<b>DIPLOMAT DENTAL SOLUTIONS</b>	<b>Diplomat Dental s.r.o., Vrbovská cesta 17, 921 01 Piešťany, Slovak Republic</b>		
	<b>Change description:</b> Short, long assistnt arm	<b>Change is valid for:</b> Model One 100	<b>Technical information</b> <b>No: 004</b>

## New short and long assistant arm for Model One 100

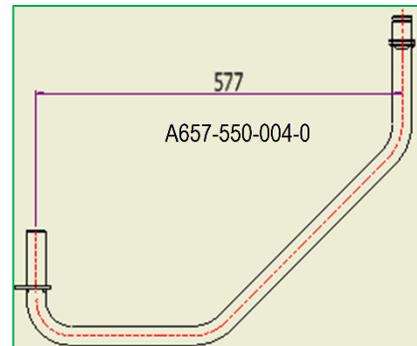
We hereby inform you about the change of the assistant arms length.

Short assistant arm length will be 270 mm.

Long assistant arm length will be 577 mm.

**The sale of the simple assistant arm in the currently available length 320 mm will be terminated when stock is sold out.**
